6 Island St.

Slope Stabilization

Project Name: Slope Stabilization and Erosion Control
Carl Collenberg, Applicant
Project ID: 10-79900034
Project Address: 6 Island Street, Portland Maine
CBL: 431-B-001-001
Planner: Jean Fraser

Woodard & Curran has reviewed the Development Review Application for the Minor Site Plan for the Arkel Slope Stabilization Project located at 6 Island Street, Portland, Maine. The proposed project includes removing a failed concrete wall and re-grading the slope with a filter fabric liner and riprap cover along the owners' property shoreline.

SECTION A-A
RIPRAP REVENTMENT
SCALE, 1" = 10' (H&V)

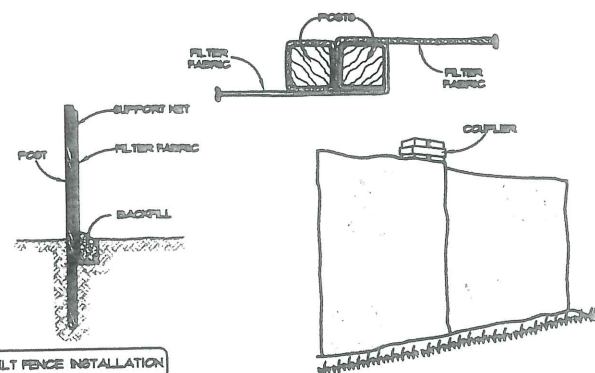
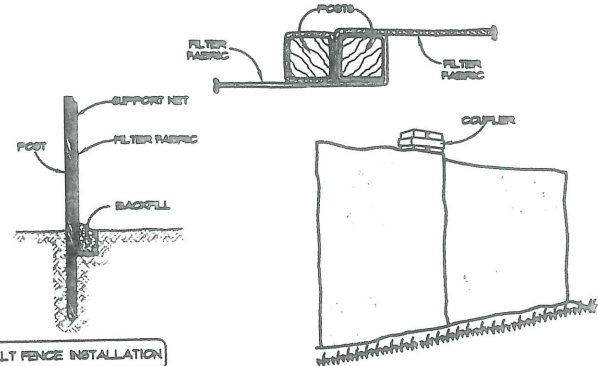
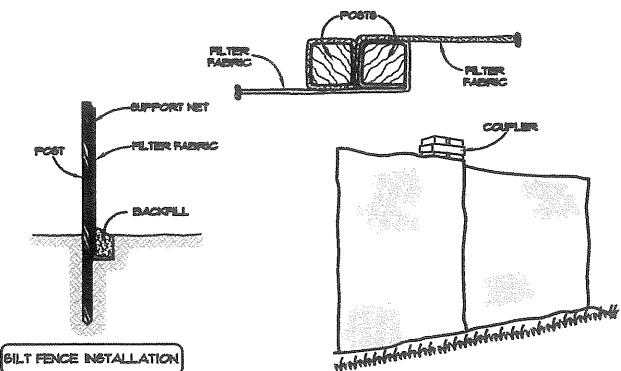
- Please provide a temporary construction entrance detail in accordance with the Maine Department of Environmental Protection's (MaineDEPs) Erosion and Sediment Control BMPs.
- In accordance with the MaineDEPs Erosion and Sediment Control BMPs, the minimum thickness of the riprap layer shall be 2.2 times the maximum stone diameter (for a D50 of 12 inches or smaller), but not less than six inches. For D50 specified greater than 12 inches, the riprap layer thickness shall be two times the D50. Additionally, the edges of the geotextile fabric should overlap a minimum of 12 inches and the upper end of the cloth should be buried a minimum of 12 inches. The riprap details provided do not specify these requirements.

Thank you Jean. I'll revise the plan according to the W+C memo with regard to the fabric and rock details. Once I have an approval from DEP, I'll attach that letter with the revised plan.
